Item #1B:
Signage, Landscaping, Lighting, Site Plan & Building Elevations
For Harbor Retirement Associates Senior Living Center

ITEM #3: For the **ARCHITECTURAL COMMISSION** on **MONDAY, June 16th @ 7:00 P.M.**

REQUEST: Consideration of a request for an amendment to the previously approved Special Use Permit and Planned Unit Development approval known as the Fairfield Village Planned Unit Development and with the R-2 PUD District to provide for a senior living center with Memory Care and Assisted Living Facilities and specifically the signage, landscaping, lighting, site plan/plat and building elevations proposed for the property at 1190 Old McHenry Road, submitted by Harbor Retirement Associates.

ELEVATIONS
06.03.2014 ZBA SUBMISSION

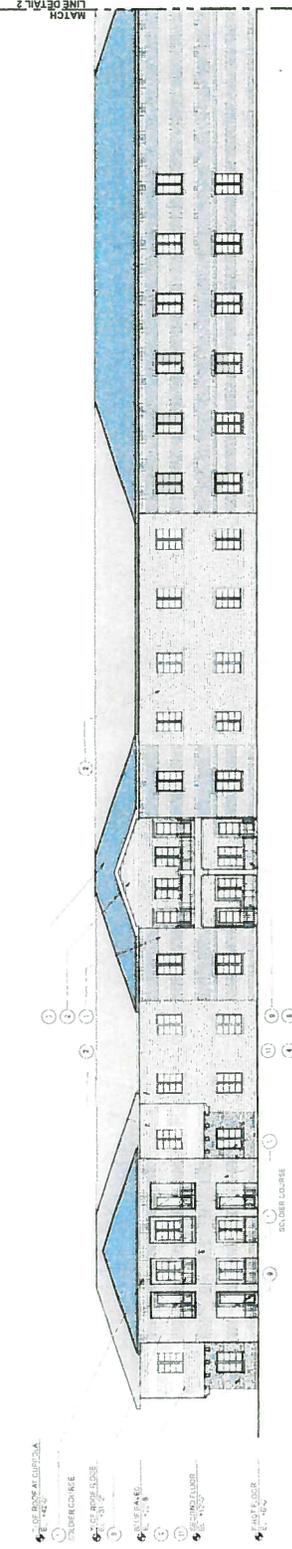
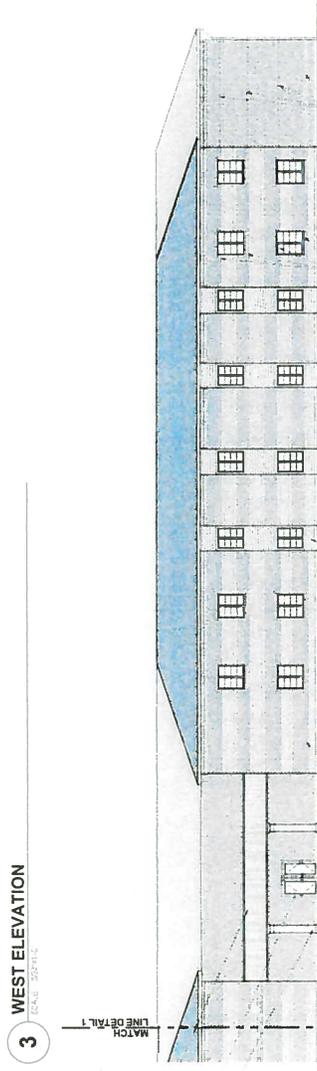
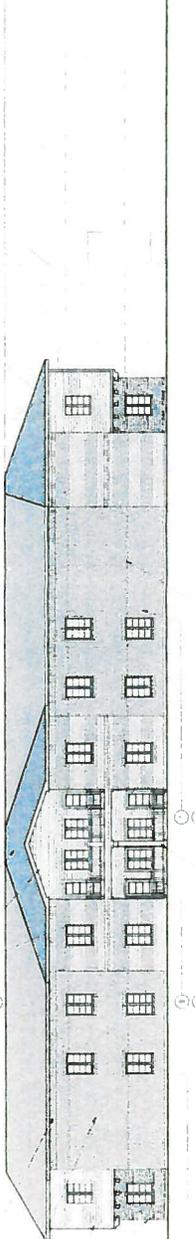
Petitioner has submitted elevations for the proposed structure. As proposed the structure would be two stories tall with building height of 35 feet or less. The only exception to the build height is cupola proposed in the center of the structure. This feature is largely decorative and serves to mirror the architecture in the Sunset Grove Development. Petitioner has asked for relief from the 35’ height maximum to 42’ for the cupola in this proposal.

A small portion of the entrance canopy (the “At Porte Cochere”) on the east side of the structure encroaches beyond the building setback but is located outside of the scenic corridor area. Petitioners indicate this structure is necessary to the facility from both the practical and aesthetic perspectives of the building.

The structure will be constructed largely of masonry (brick) and hardi-board exterior with stone accents and an asphalt shingle roof (elevations and materials list attached). Elements the building façade were designed to capture the essence of the Sunset Grove development across the street.

Elevations should be considered recognizing the concepts and recommendations of the proposed “downtown master plan” to the greatest extent possible. Coordination of the look of this proposal with other developments in the area (i.e. Sunset Grove) should also be considered.

PLAN SITE
06.03.2014 ZBA SUBMISSION

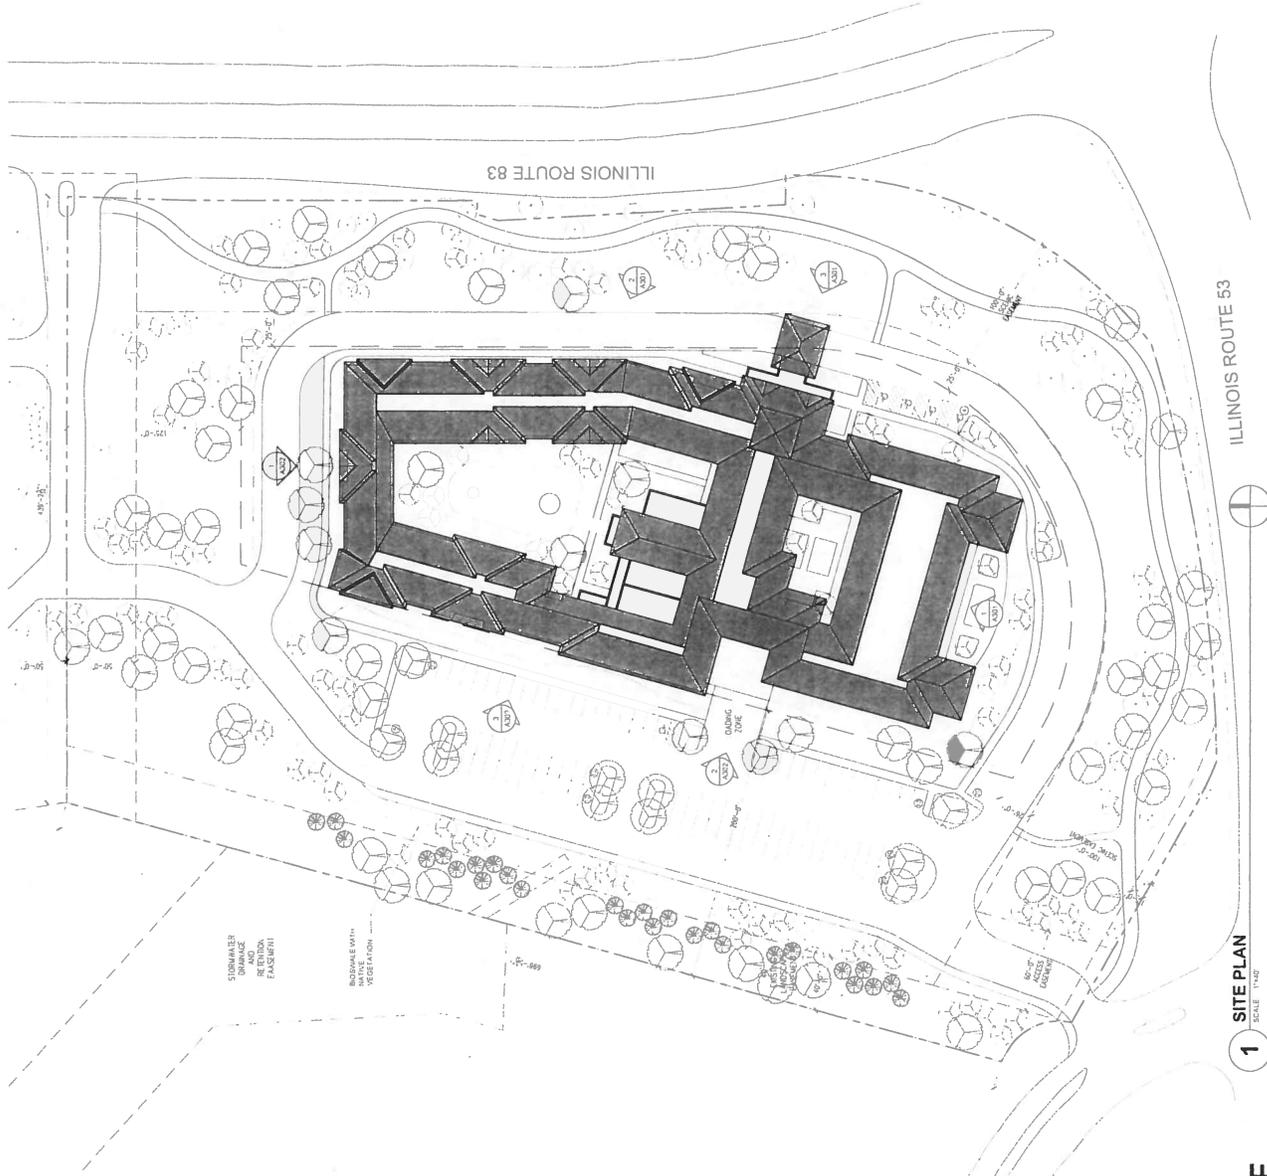
Petitioner has submitted landscape plan for consideration by the AC. As is practical existing trees on-site will be preserved.

The existing 40' buffer yard along the west side of the property will remain as platted and be enhanced with additional planting. As proposed plantings will be largely native shade and ornamental trees. Evergreen trees will also be used and in particular along the western landscape easement.

Review of the landscape plan should be undertaken with consideration of the residential uses to the west. Petitioner has kept parking near the building and increased landscaping along the 40’ buffer yard to the west. Of note the buffer yard area has deteriorated over time and landscaping (as well as maintenance) should serve to greatly improve the effectiveness of this buffer.

The site plan/plat as submitted by the petitioner has been carefully crafted to work within the constraints of the approved PUD. These constraints have been an impediment to redevelopment of this property. Of note the site plan is more or less consistent with the current configuration of the site and works within the plat constraints of the PUD as well.

2 TRASH ENCLOSURE FRONT ELEVATION
SCALE: 1/2"=1'-0"

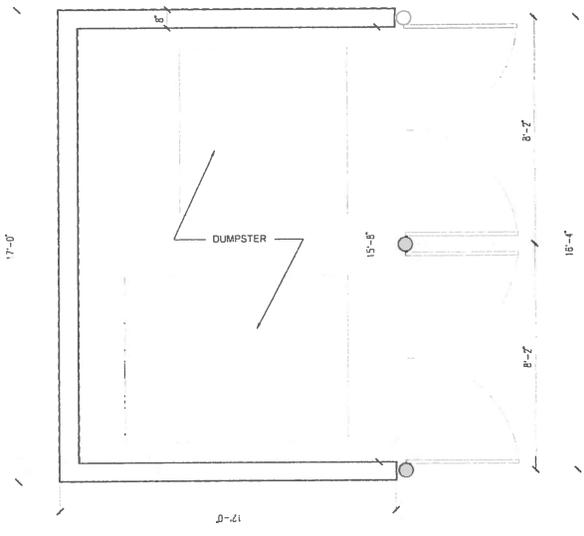
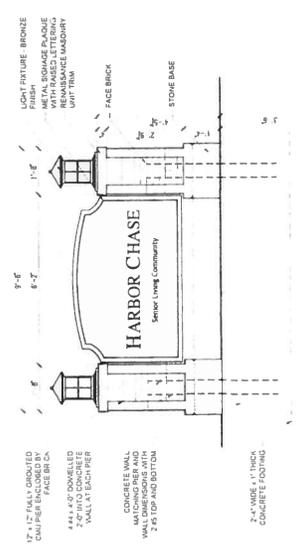
Trash enclosure elevations have been submitted as well. These will be constructed of brick on three sides with lockable wood plank gates across the opening.
